**CEDAR KEY WATER AND SEWER DISTRICT**  
**INVITATION TO BID NO: 2025-01**  
**LIFT STATION REHABILITATION – PHASE II**  
**ADDENDUM NO. 5**

**January 27, 2026**

**CEDAR KEY**  
**SANITARY SEWER**  
**LIFT STATION**  
**REHABILITATION-PHASE II**

**M-904**

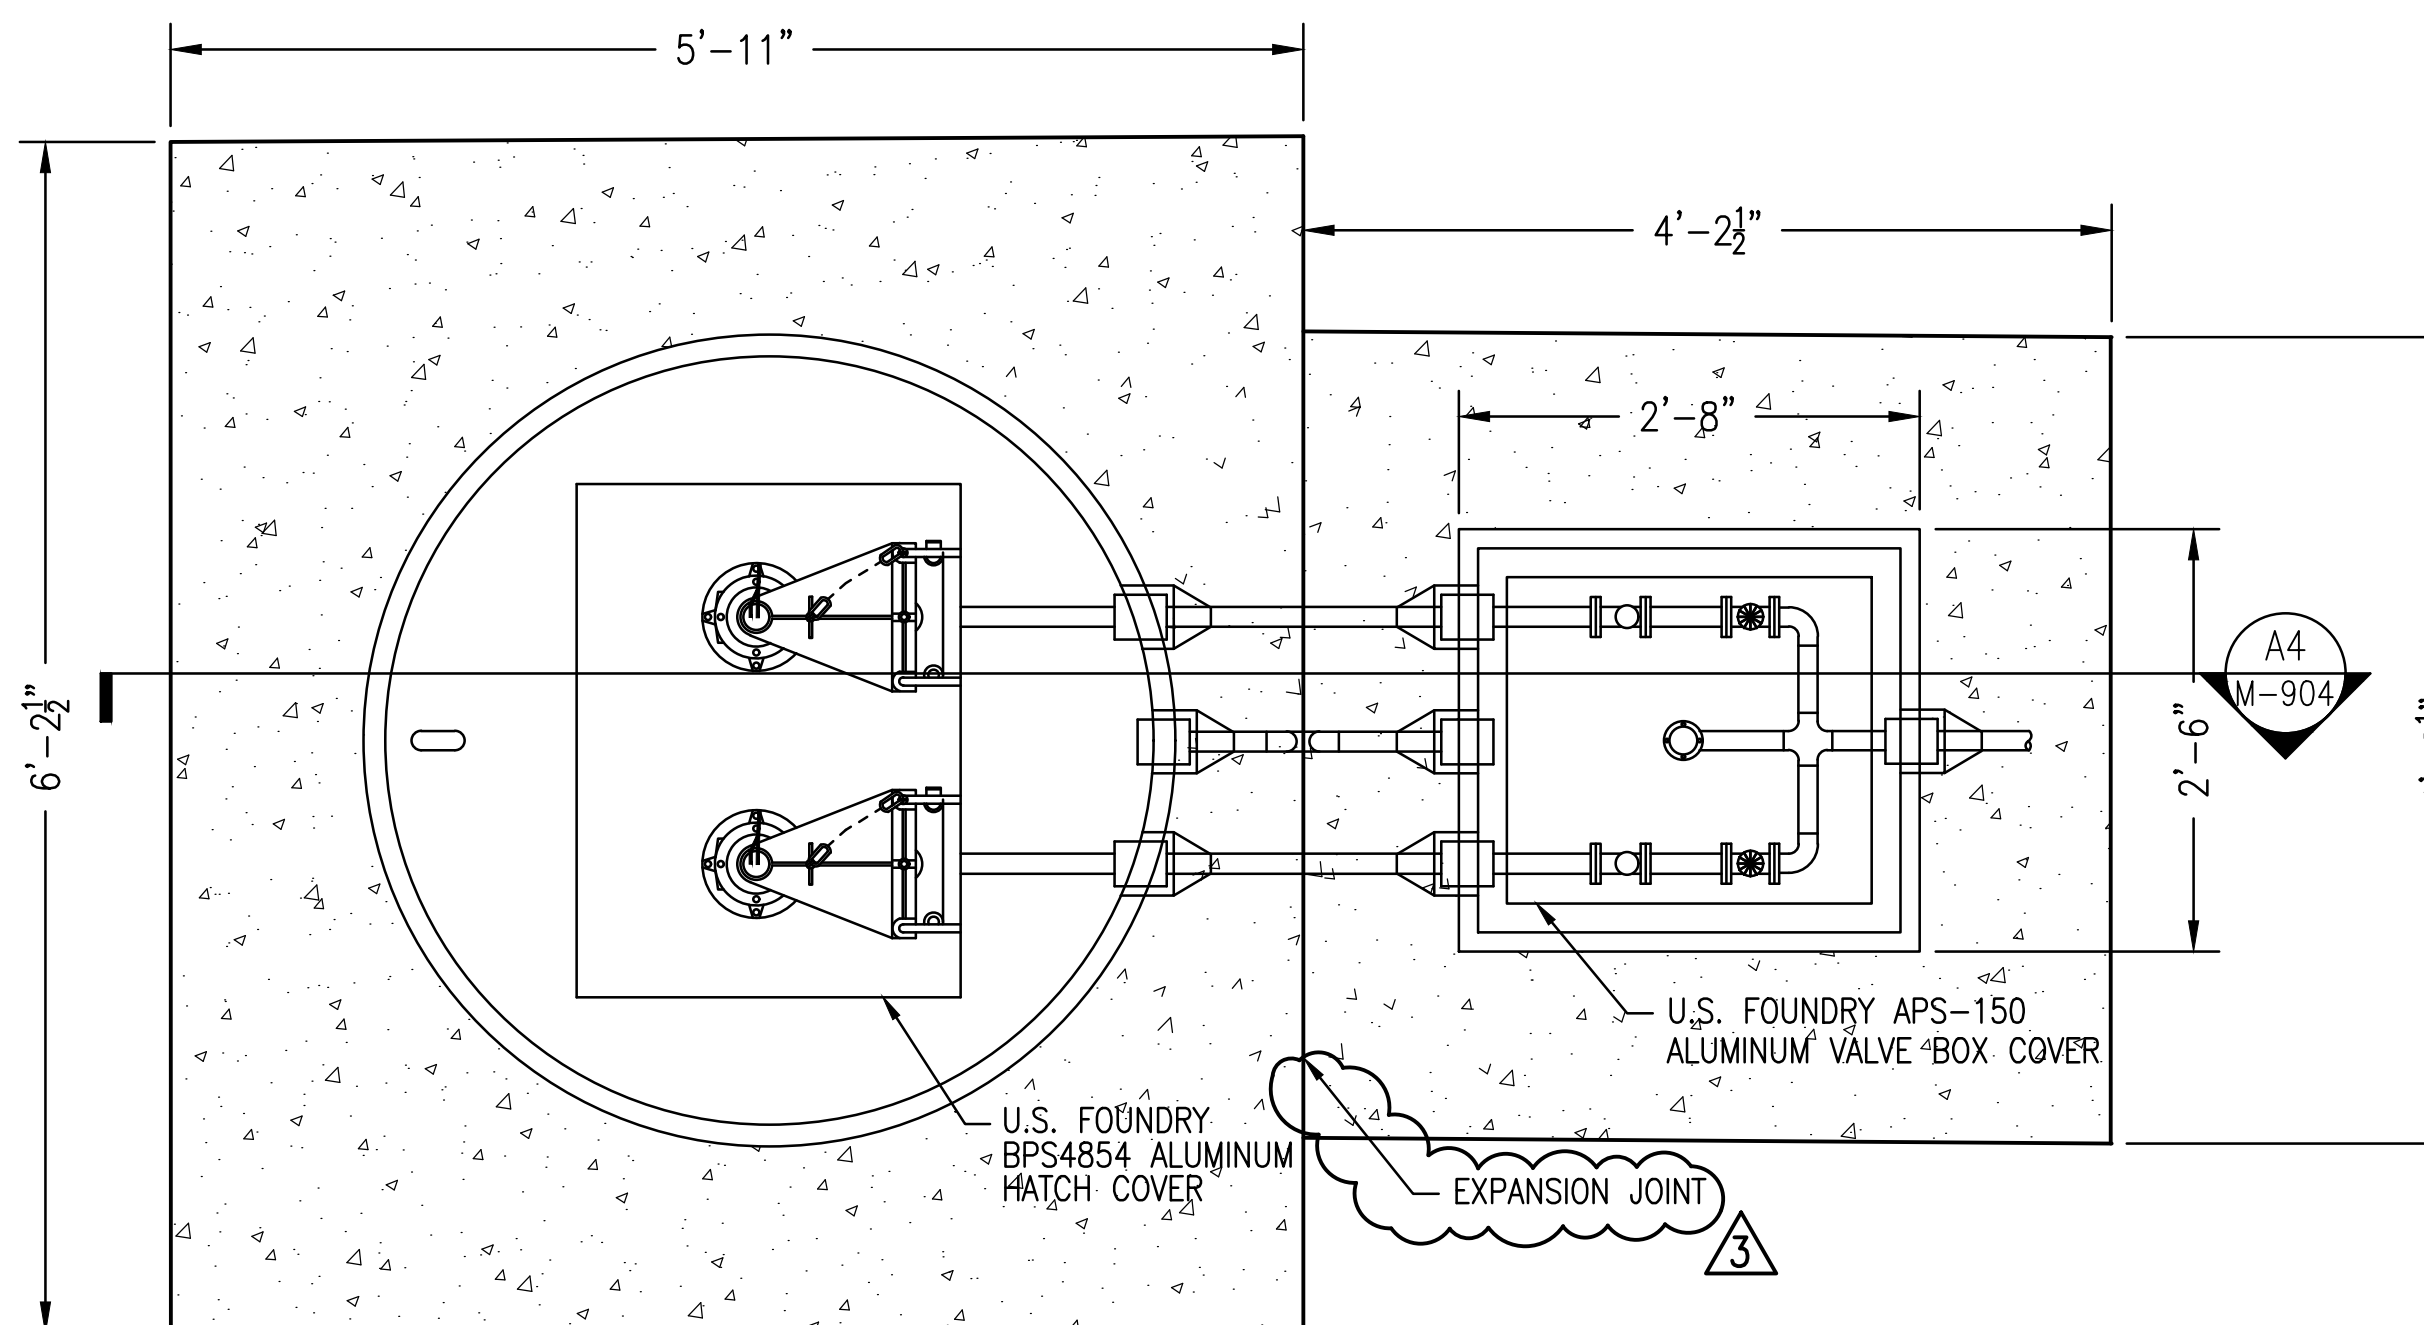
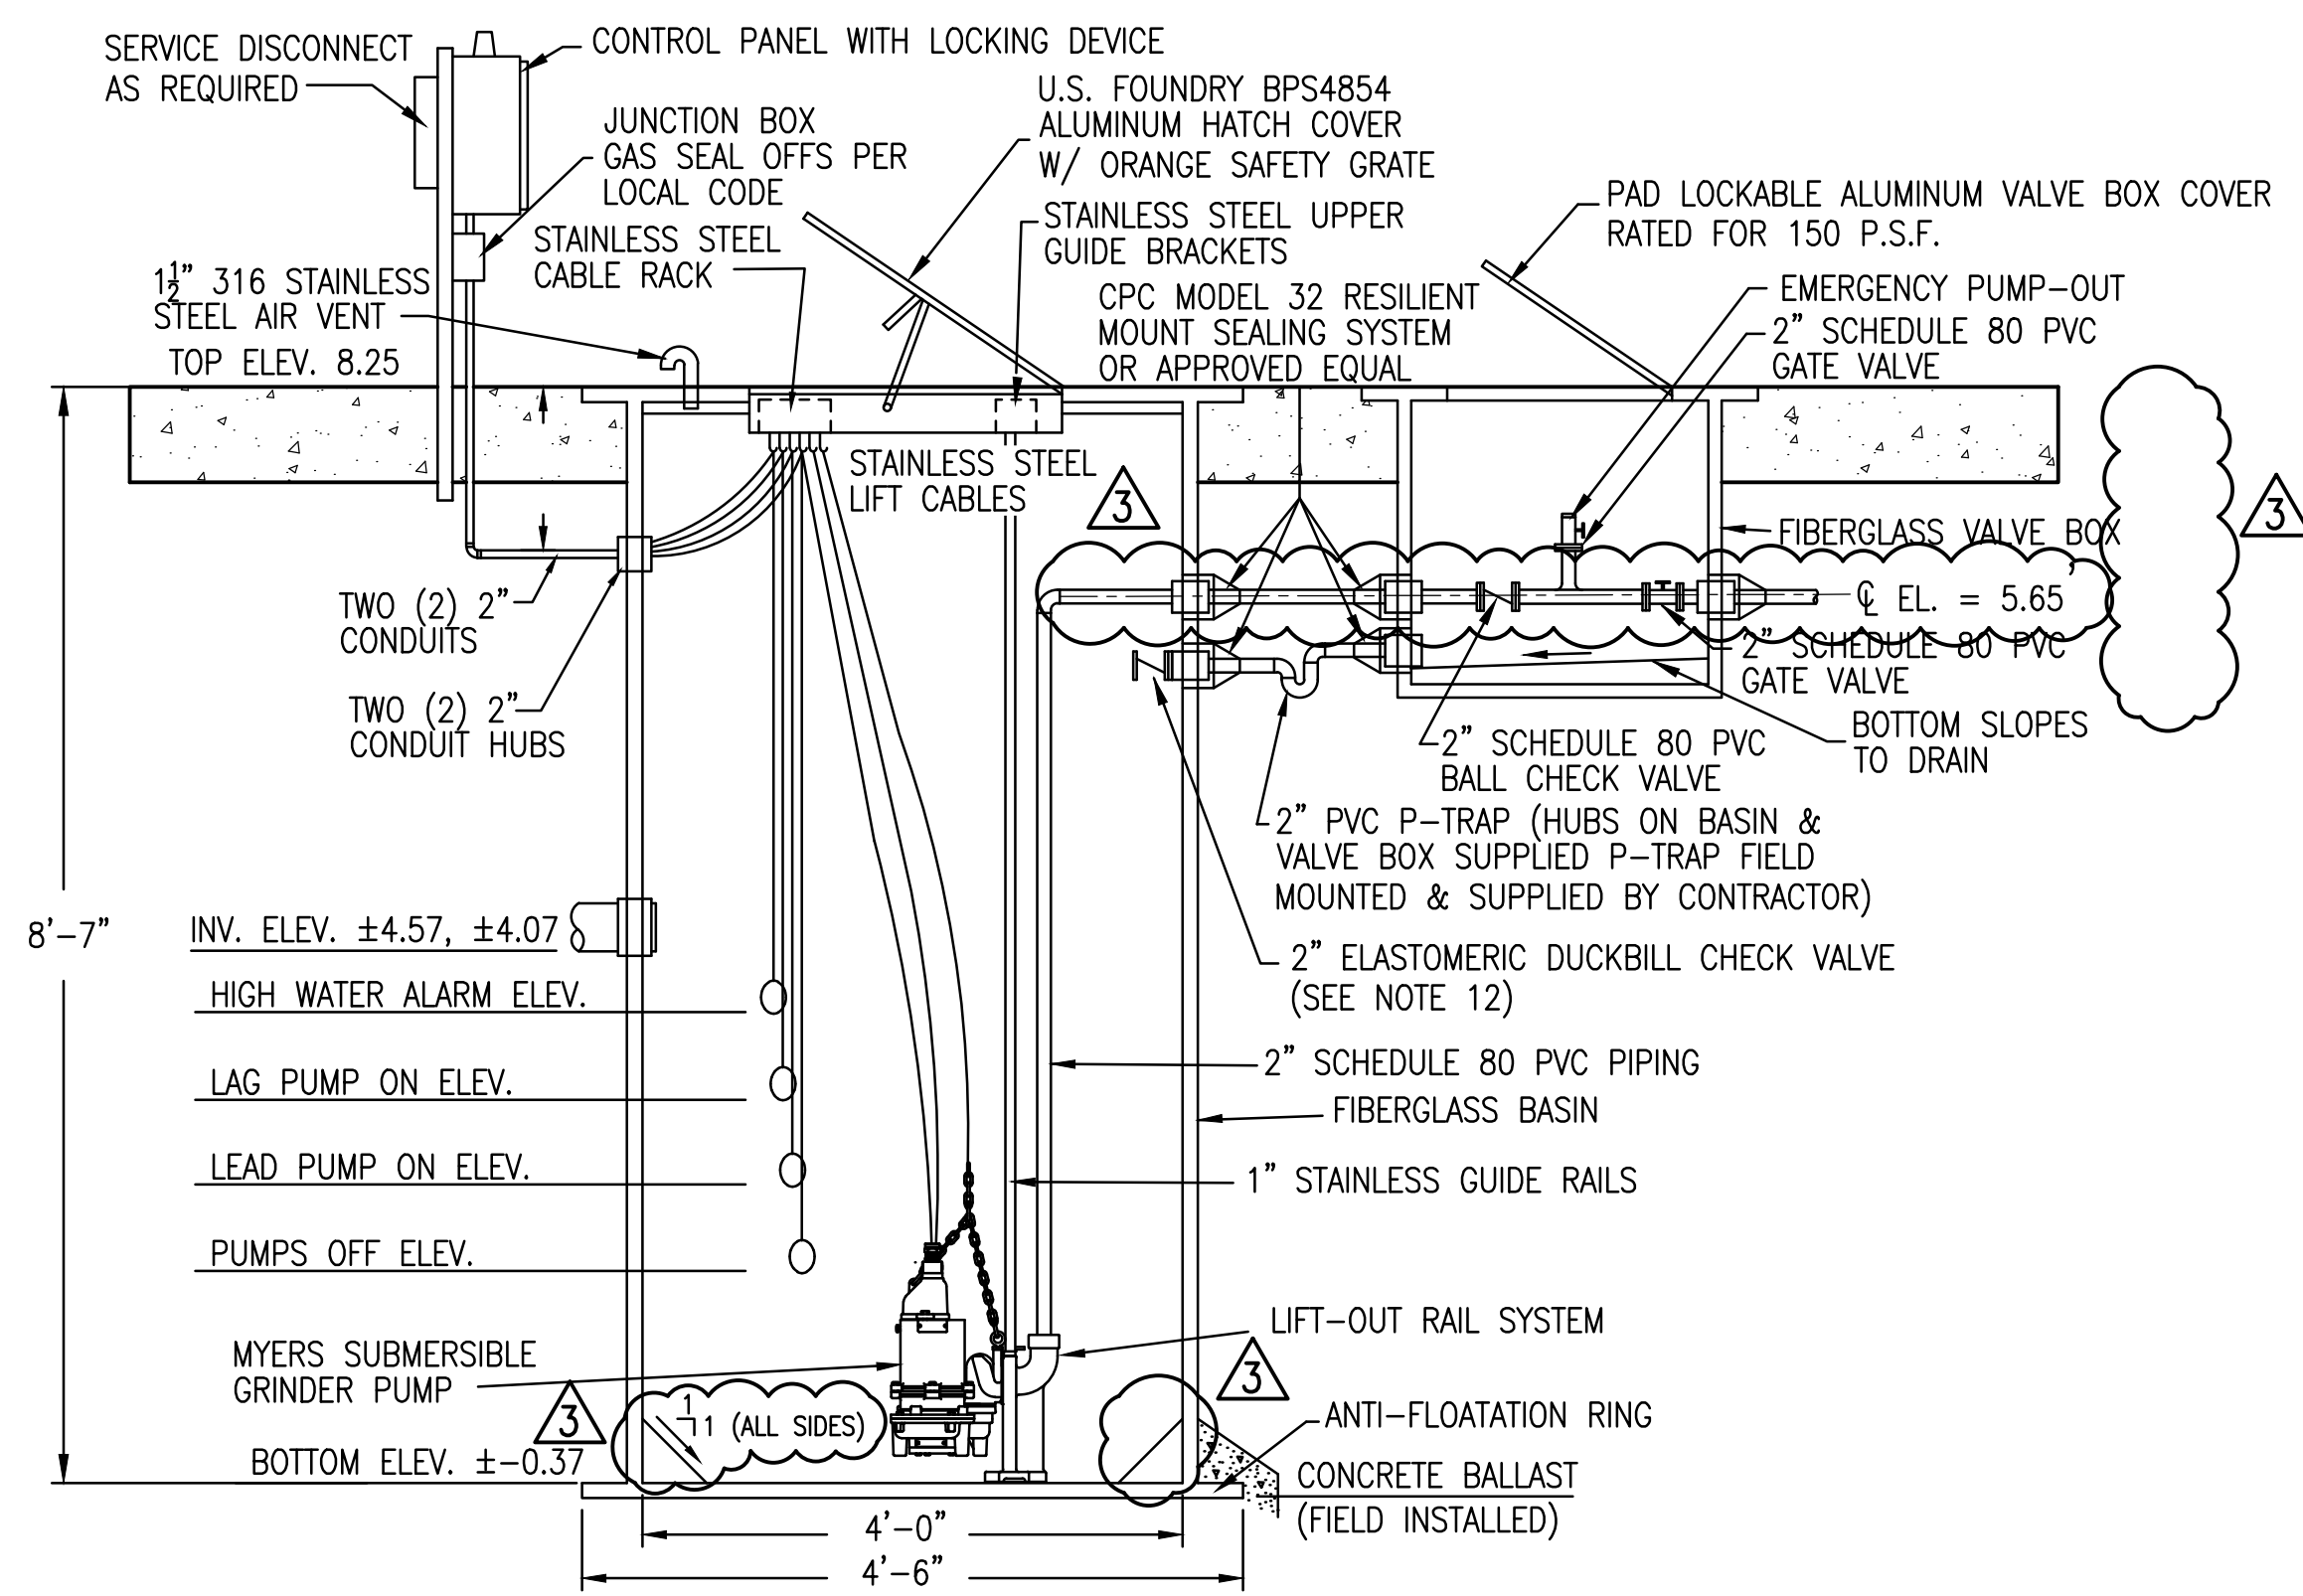
ITEM	DRAWING SHEET	CHANGE
1.	M-902 (REVISED SHEET)	The Pump Station Improvement Schedule was updated accordingly to reflect the adjusted operating conditions and float elevations.
2.	M-903 (REVISED SHEET)	The Pump Station Improvement Schedule was updated accordingly to reflect the adjusted operating conditions and float elevations.
4.	M-904 (REVISED SHEET)	The revise drawing sheets includes the updated discharge piping CL elevation and fillets required around the bottom of the fiberglass wet well basin per FDEP requirements.

12. THE ELASTOMERIC DUCKBILL CHECK VALVE SHALL HAVE A DOCUMENTED CRACKING PRESSURE OF  $\leq 2$ " WATER COLUMN & SUITABLE FOR WASTEWATER APPLICATION.
13. FIBERGLASS WET WELL SHALL HAVE 1:1 FILLETS PROVIDED WITH THE FIBERGLASS WET WELL ASSEMBLY.
